309 KING STREET NEWCASTLE

COUNCIL RFI - SOLAR

25 JUNE 2025

CONTENTS
SOLAR ACCESS COMPLIANCE RESPONSE

ADDITIONAL INFORMATION - TOWER B UNIT 505 - BALCONY UPDATE

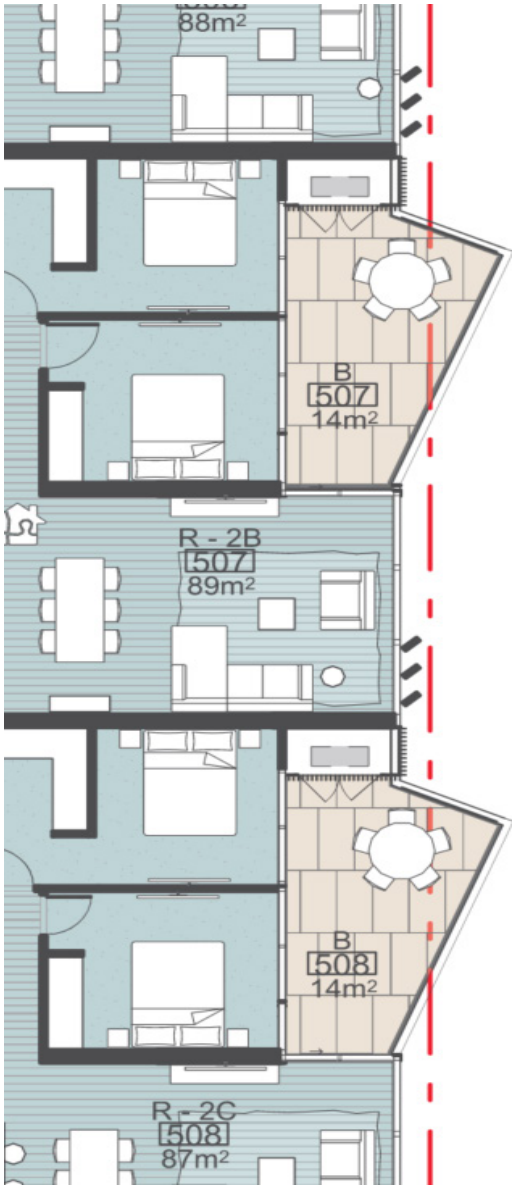
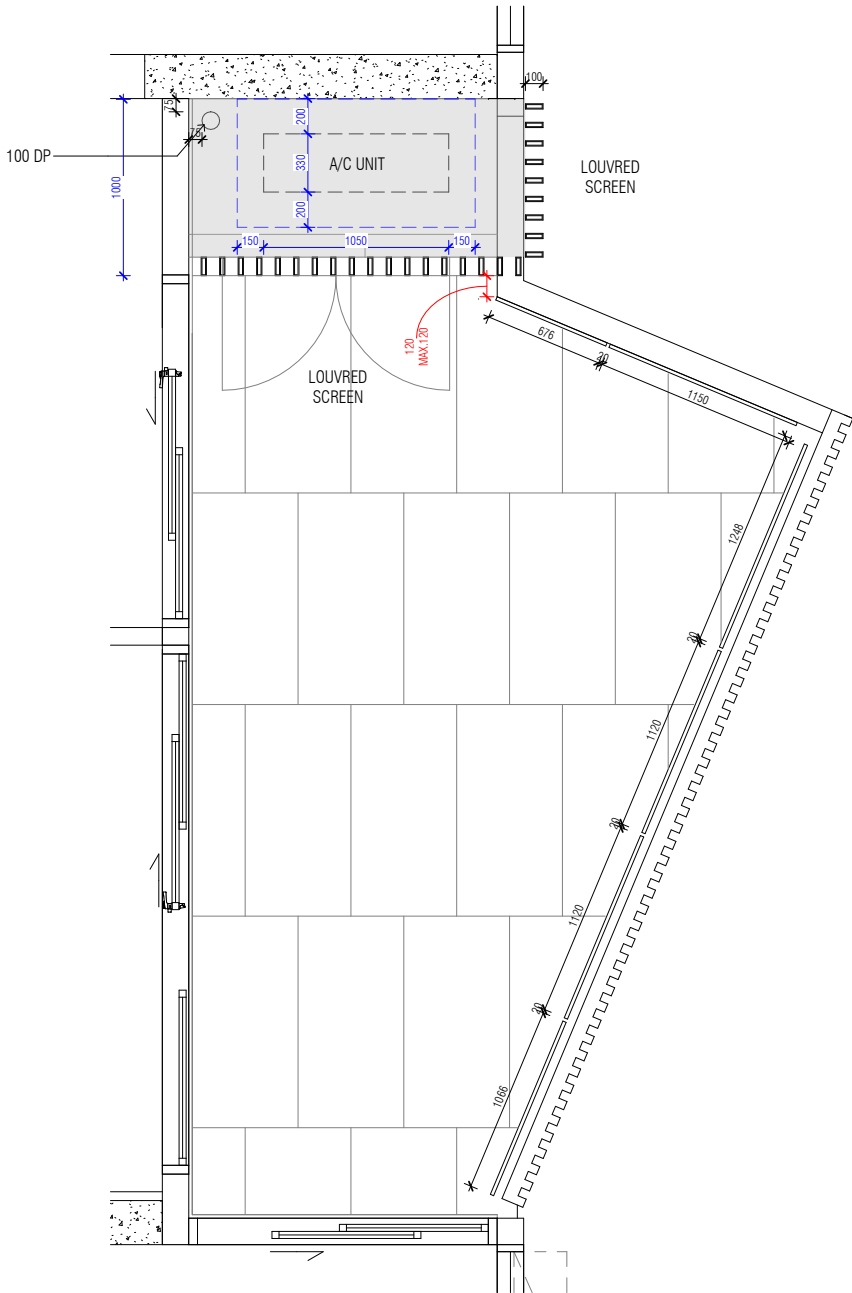
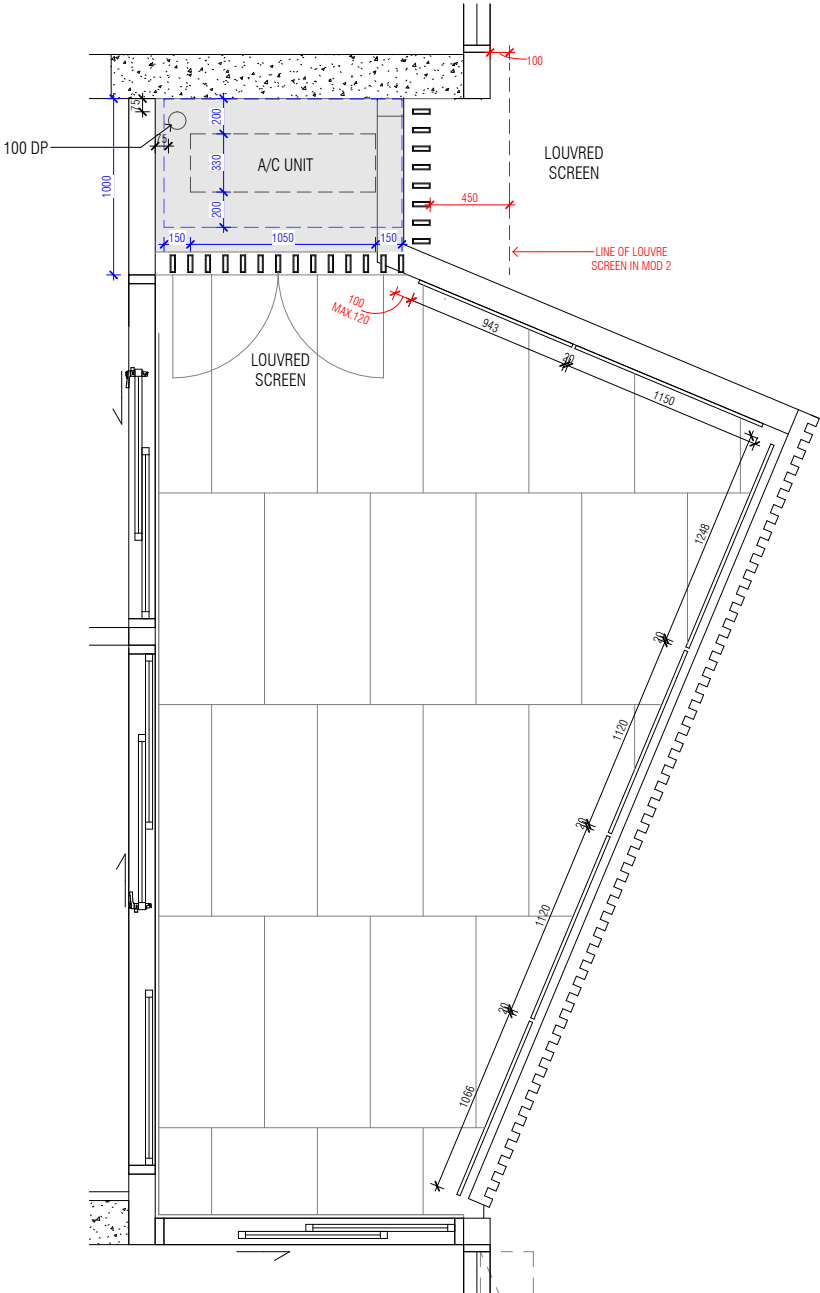
Proposed condition of consent requiring changes to apartment balconies:

1. The width of the air conditioning enclosure (also referred to as 'balcony louvres') on the eastern balconies of Tower A and Tower B must be reduced by a minimum of 450mm, as indicated on approved drawings SK558 to SK563 prepared by Fender Katsalidis Pty Ltd. Full details are to be included in the documentation for a Construction Certificate

REV. 01
DRAWING NO. SK020

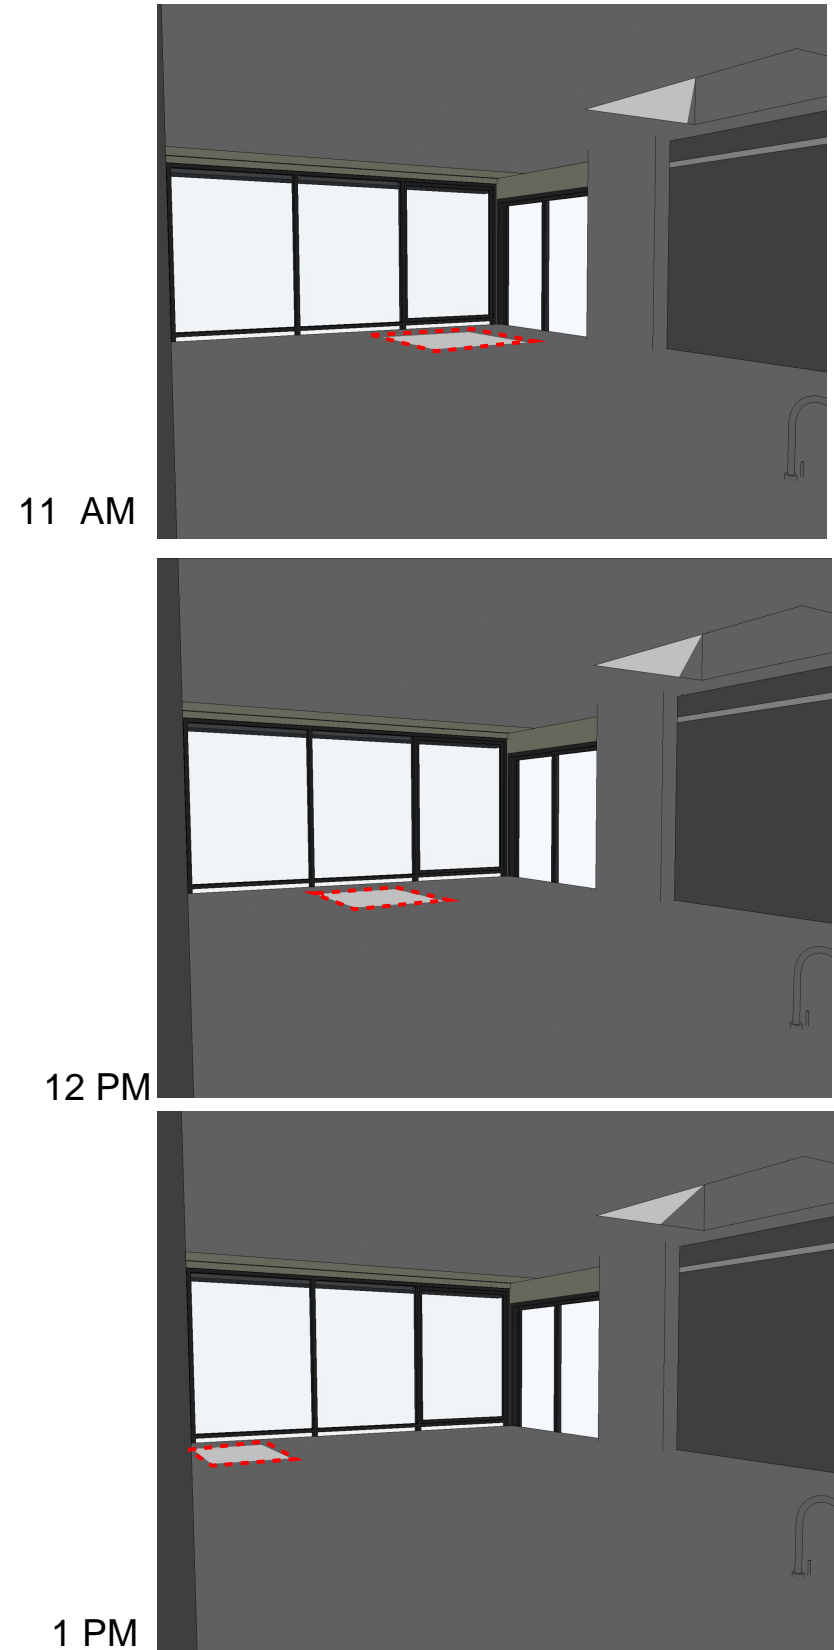
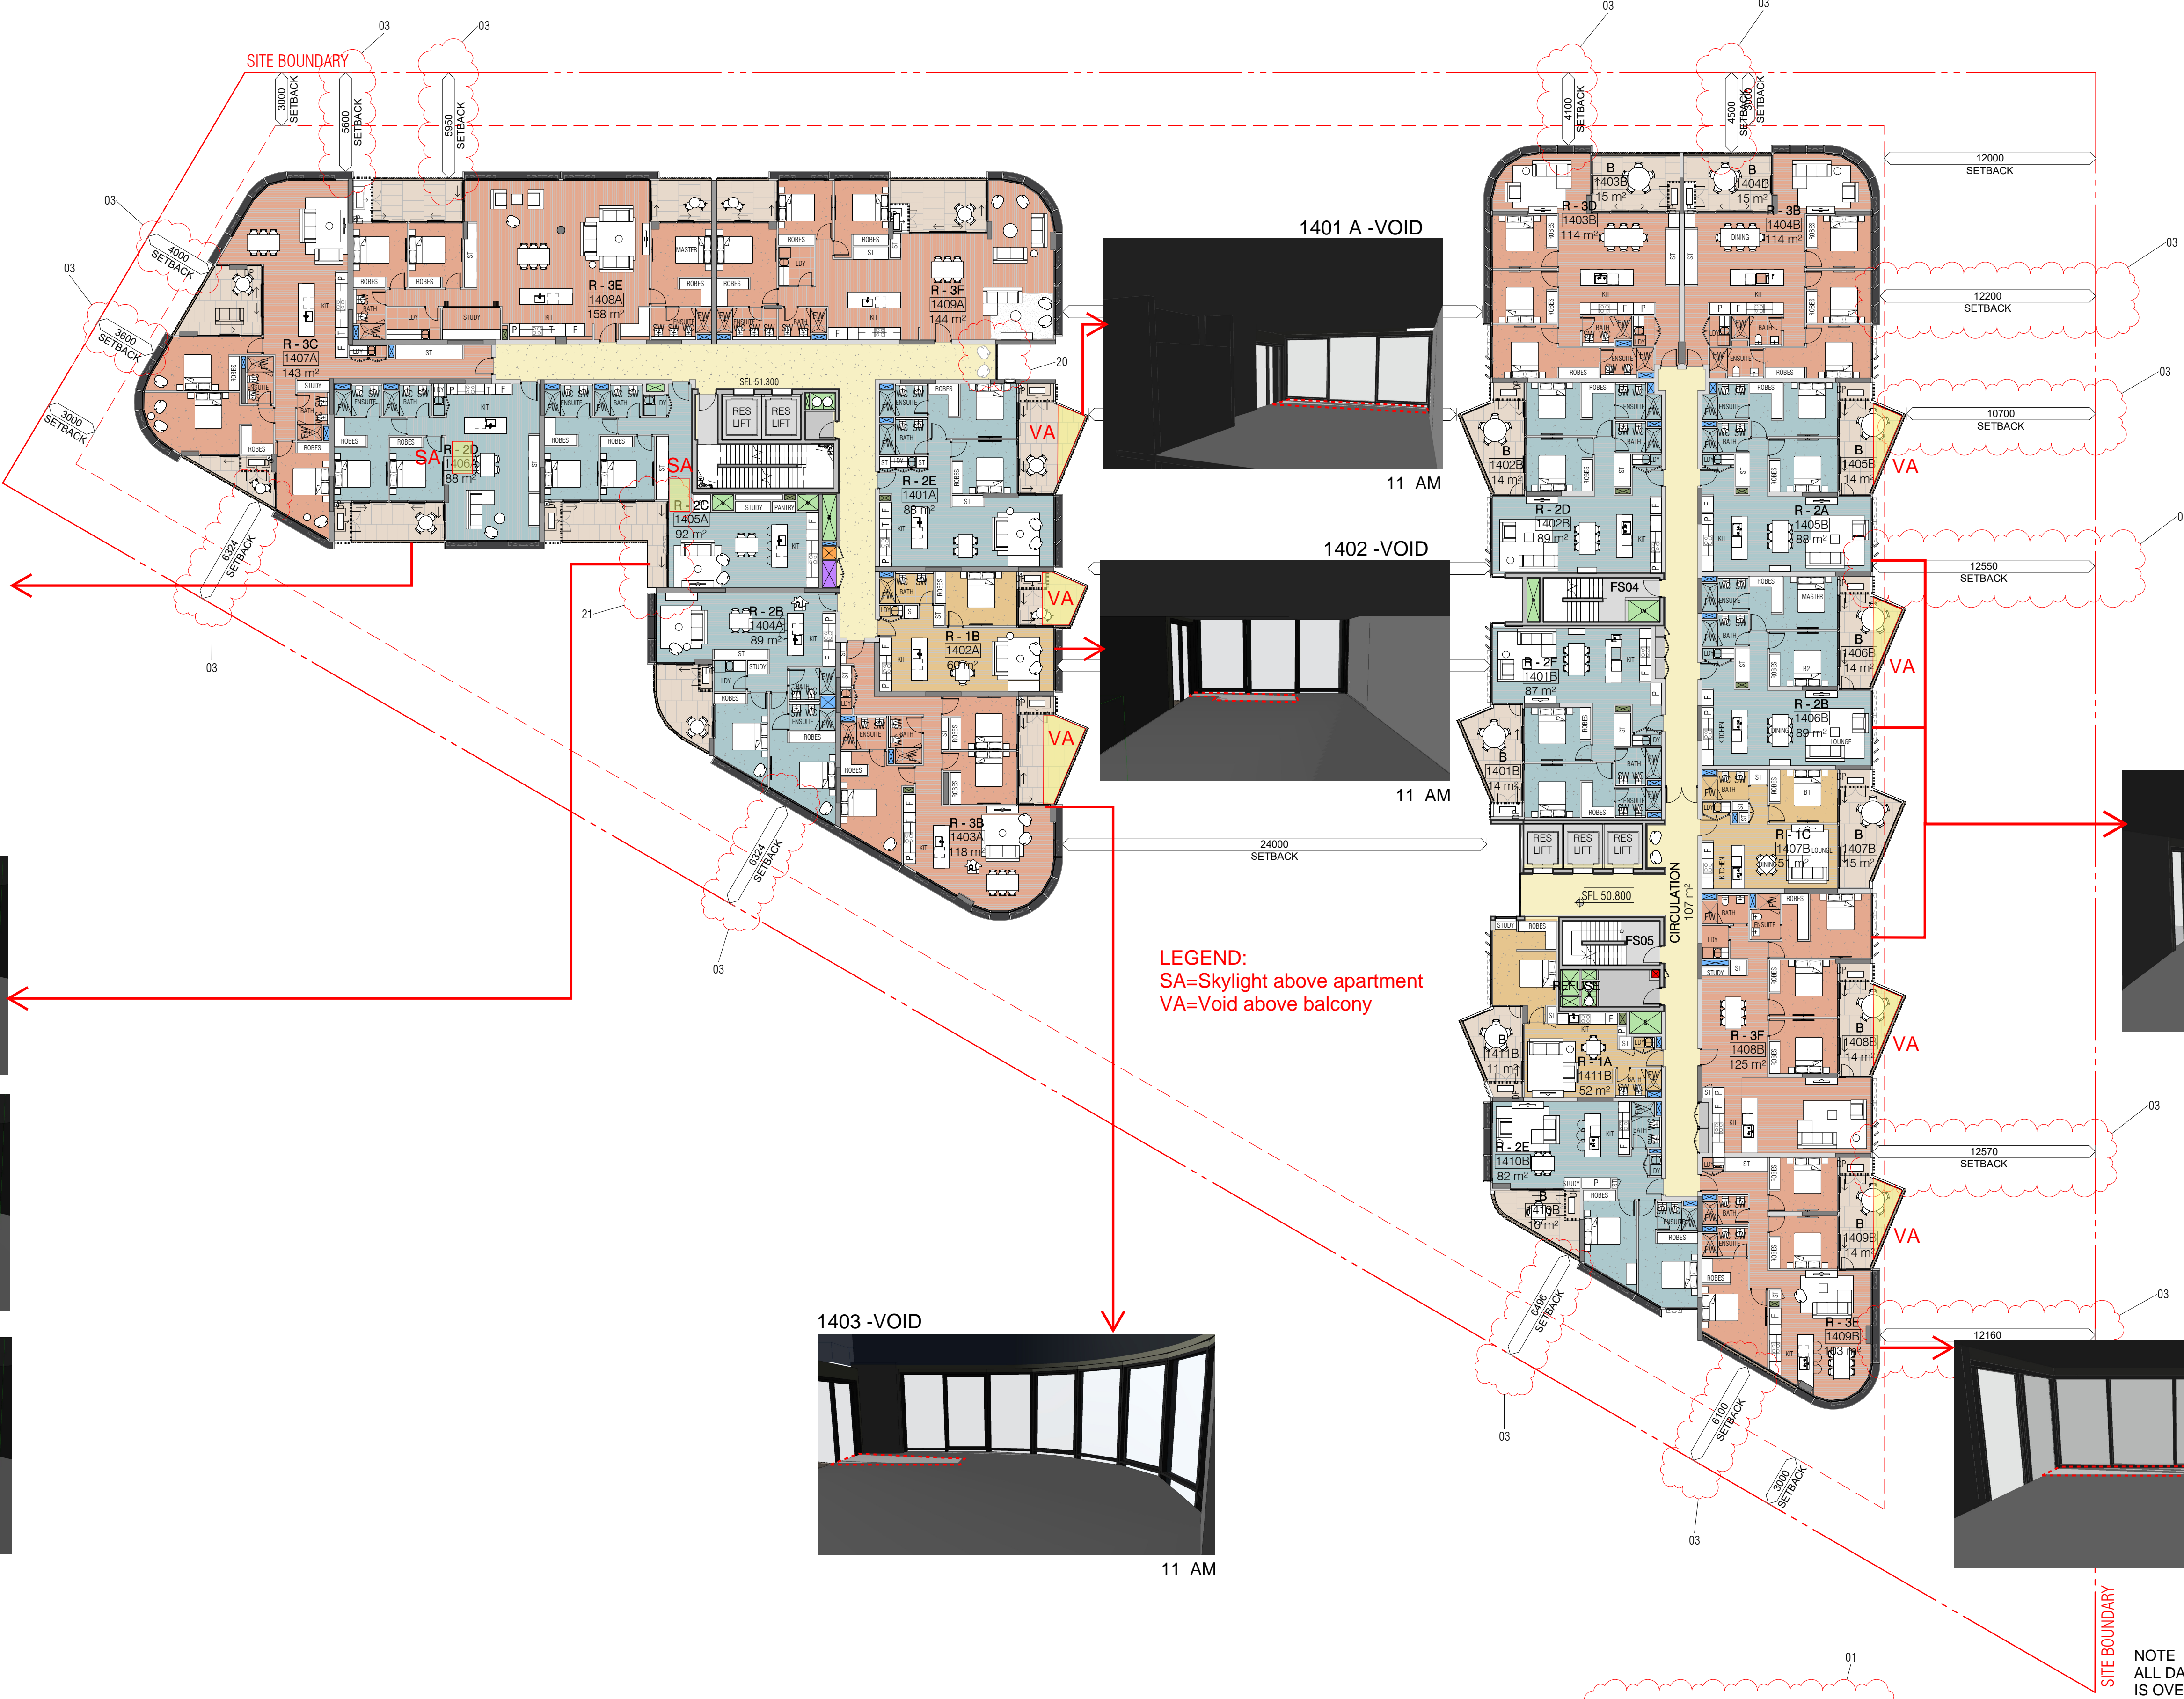
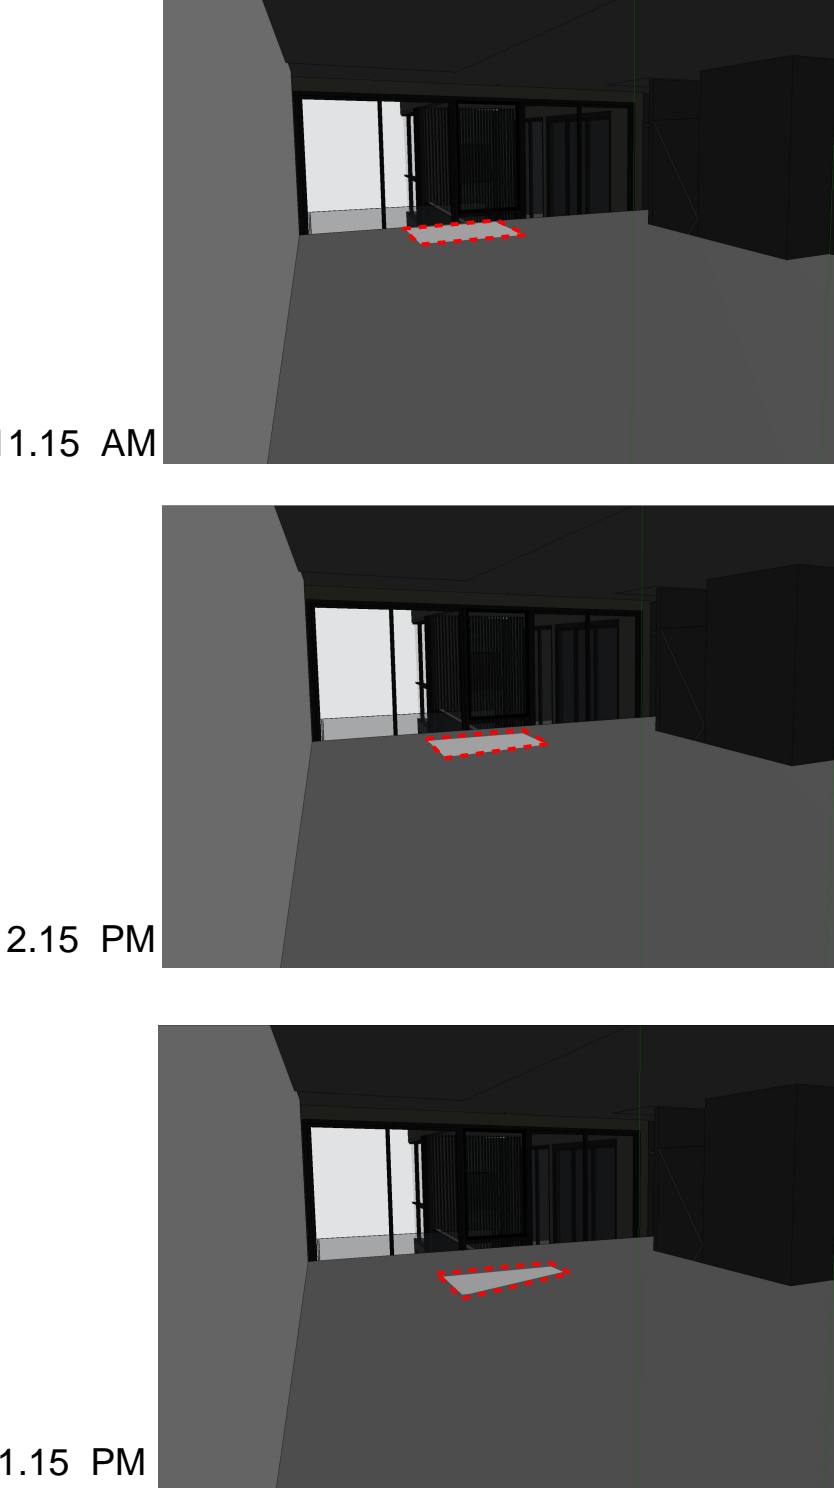
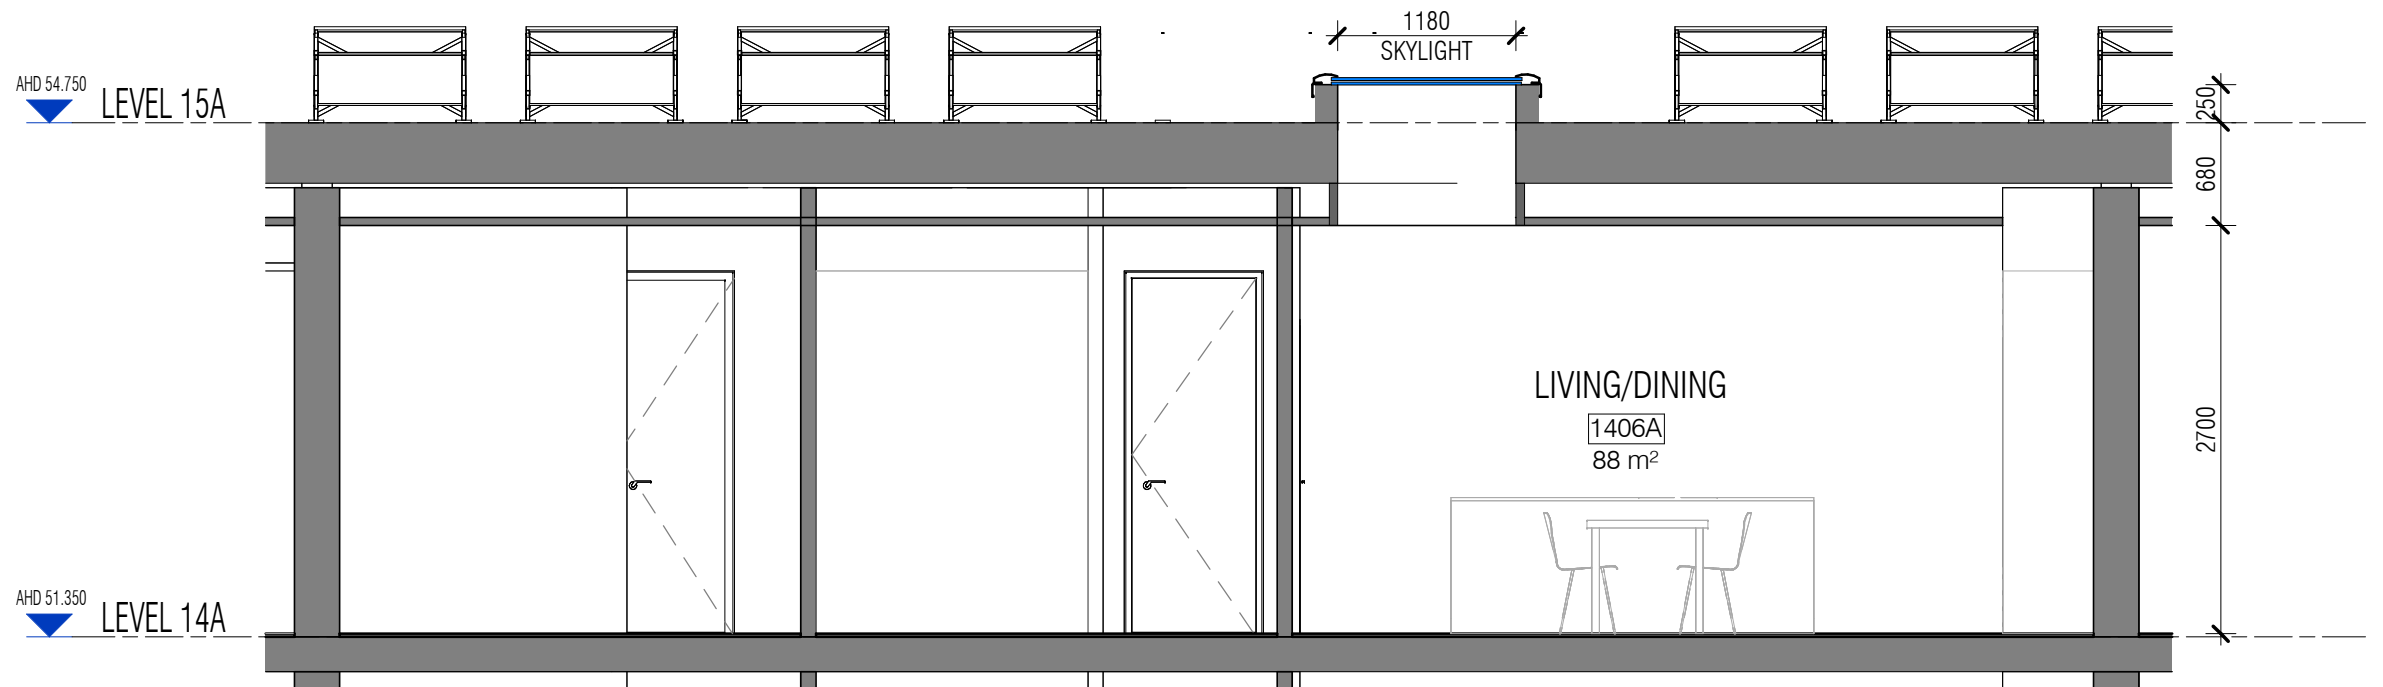
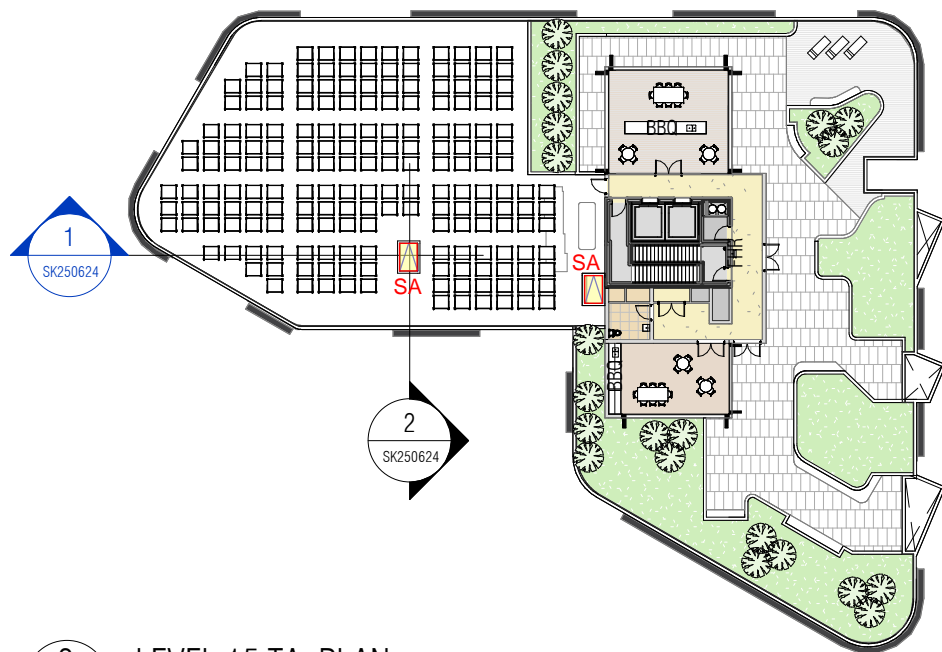
Due to solar access compliance reducing current analysis once again assumes that skylights could be used to improve the compliance percentage. The current proposal is to use a combination of skylights (2) and voids within the existing profile of the parapets (7) to bring addition sunlight into top level apartments. This has been analysed in a 3D model environment to ensure that compliant sunlight is provided

1406 - A -SKYLIGHT

1405 - A -SKYLIGHT
